Development Management Committee

Tuesday, 5 December 2023 6.30 p.m.
Civic Suite, Town Hall, Runcorn

3. PLANNING APPLICATIONS TO BE DETERMINED BY THE COMMITTEE	
(A) 20/00476/FUL - Proposed refurbishment of existing Carnegie Library building to provide a new community hub, demolition of Waterloo Centre, erection of new build development of 29 one bedroom supported living/extra care apartments with ancillary facilities, provision of access, parking and landscaping	6 - 123
<p style="text-align: center;">AND</p>	
20/00477/LBC - Application for Listed Building Consent for proposed refurbishment of existing Carnegie Library building to provide a new community hub, demolition of Waterloo Centre and remedial works to adjacent listed building. Both at Waterloo Centre & Carnegie Library, Edgerton Street, Waterloo Road, Runcorn, WA7 1JL

APPLICATION NUMBERS:	20/00476/FUL and 20/00477/LBC
LOCATION:	Waterloo Centre and Carnegie Library, Egerton Street, Waterloo Road, Runcorn, Cheshire, WA7 1JL
PROPOSAL:	<p>20/00476/FUL</p> <p>Proposed refurbishment of existing Carnegie Library building to provide a new community hub, demolition of Waterloo Centre, erection of new build development of 29 one-be

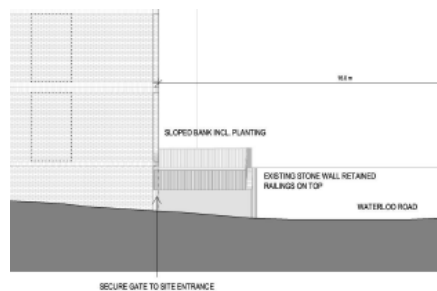
Given the Fire Escape egress point, and the secure gate to the communal garden form the parking area (see query below) at the top of the ramp is it is presumed that this is.

The ramp, with a 1:14 gradient, is not compliant for vehicles or pedestrians and there is no footpath or protected walkway for pedestrian/vulnerable users.

The gate detail in terms of effective width of the access opening is not forthcoming and therefore the ability of vehicles to pass on the ramp has not been demonstrated.

Gate detail to understand effective width is also required.

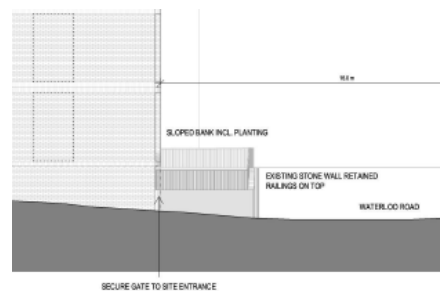
Given the Fire Escape egress point, and the secure gate to the communal garden form the parking area (see query below) at the top of the ramp is it is presumed that this is.

The ramp, with a 1:14 gradient, is not compliant for vehicles or pedestrians and there is no footpath or protected walkway for pedestrian/vulnerable users.

The gate detail in terms of effective width of the access opening is not forthcoming and therefore the ability of vehicles to pass on the ramp has not been demonstrated.
